**APPLICATION FOR PERMISSION
UNDER SECTION 16 OF
THE TOWN PLANNING ORDINANCE
(CAP.131)**

Applied use/ development 申請用途/發展	Proposed Light Public Housing Development and Associated Filling / Excavation of Land on a 3 Years Temporary Basis 擬議臨時簡約公屋發展及相關填土/挖土工程 (為期 3 年)

**SECTION 16 PLANNING APPLICATION
THE TOWN PLANNING ORDINANCE (CHAPTER 131)**

Further to comments received from Agriculture, Fisheries and Conservation Department ("AFCD"), Urban Design & Landscape ("UD&L") Section of Planning Department ("PlanD"), Environmental Protection Department ("EPD"), and Drainage Services Department ("DSD"), please find our responses provided in the enclosed Responses to Comments ("R-to-C") table (Attachment 1 refers).

Appendix A

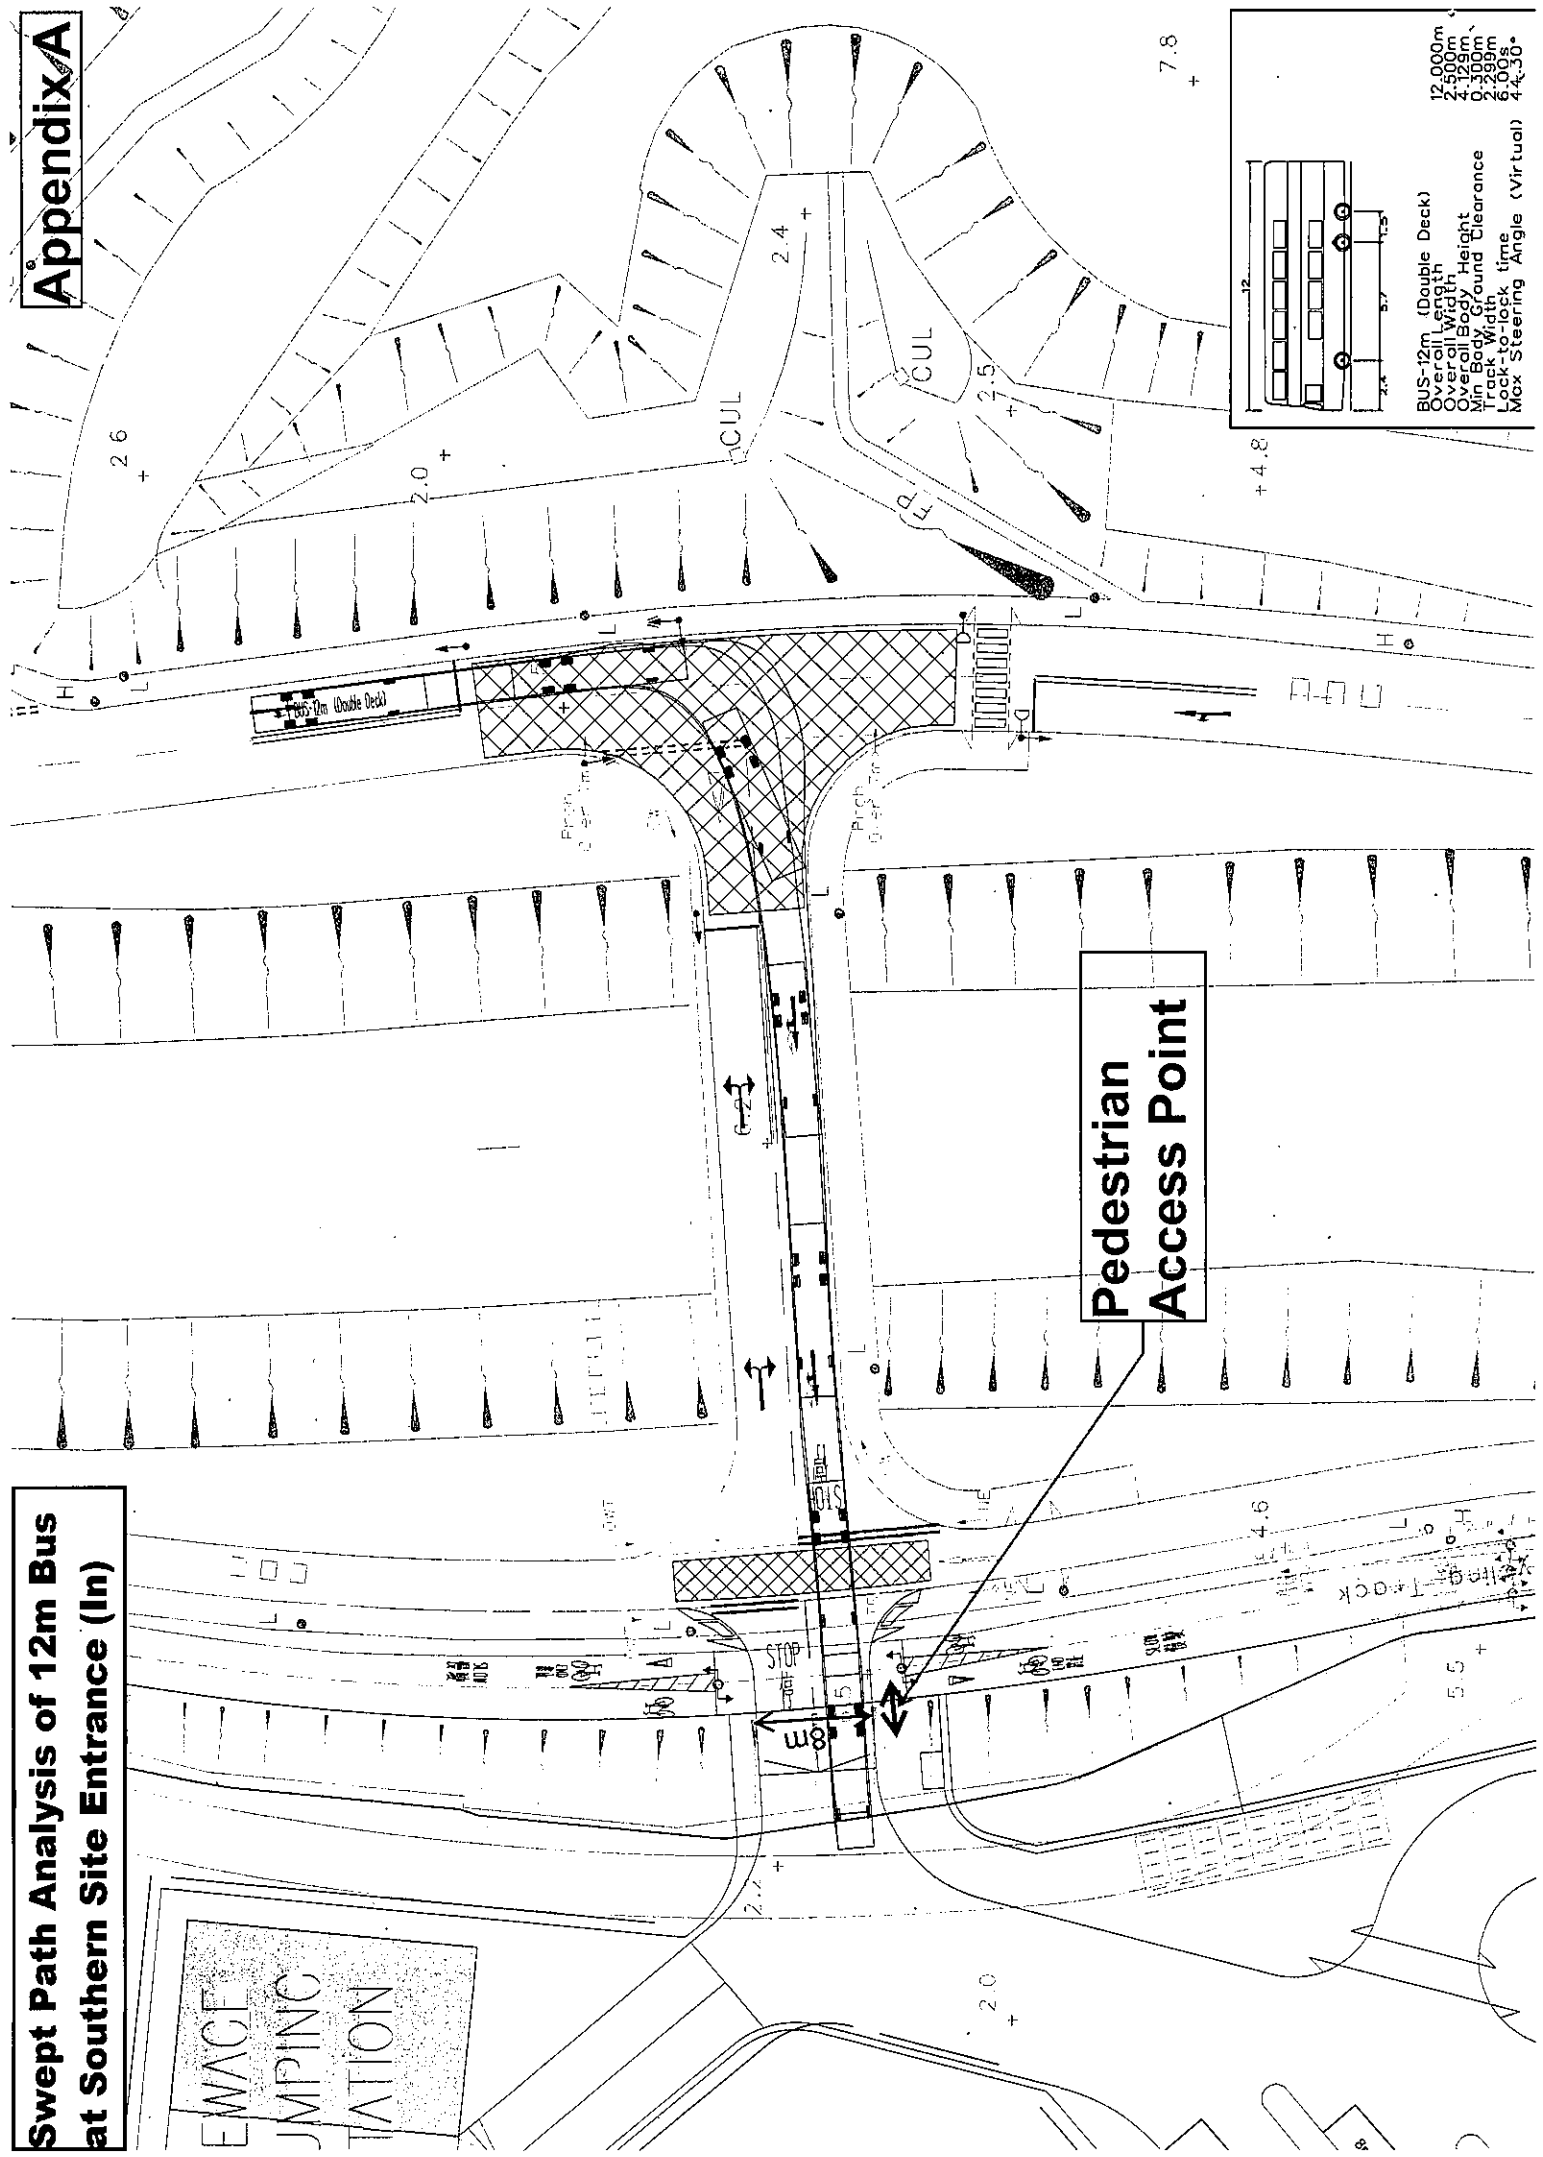
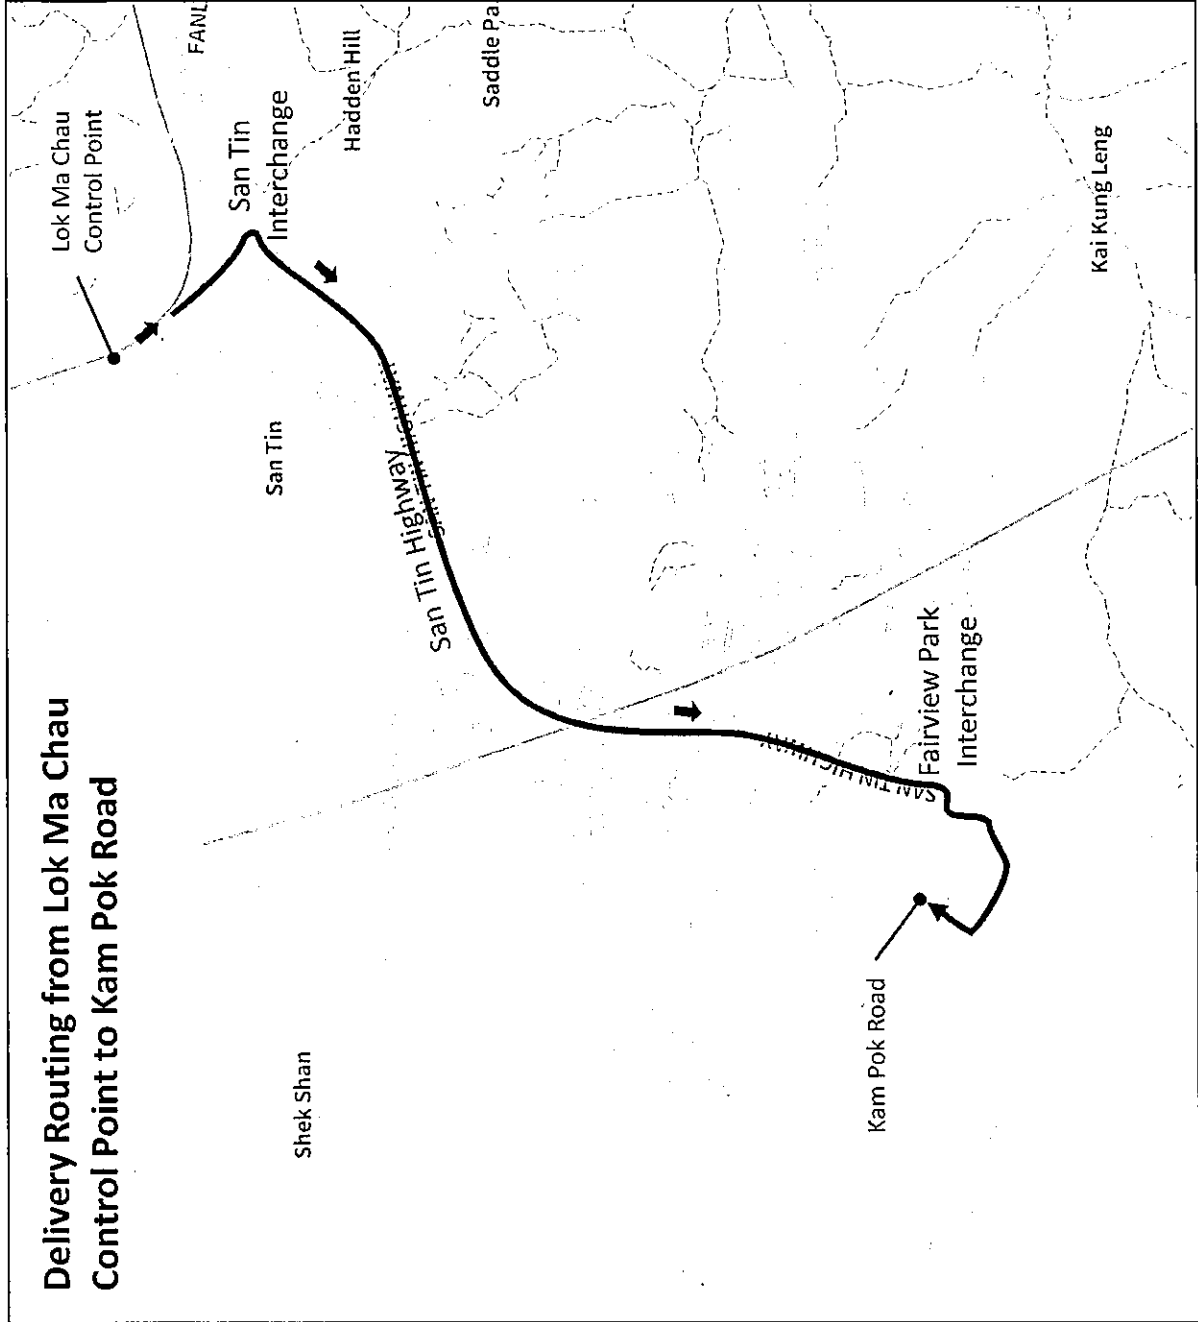
(b)	Please indicate the width of the vehicular access and locations of pedestrian access points;	Noted and please refer to the revised Appendix A (Attachment 3 refers) for the width of the vehicular access and locations of pedestrian access points are indicated in the drawing.
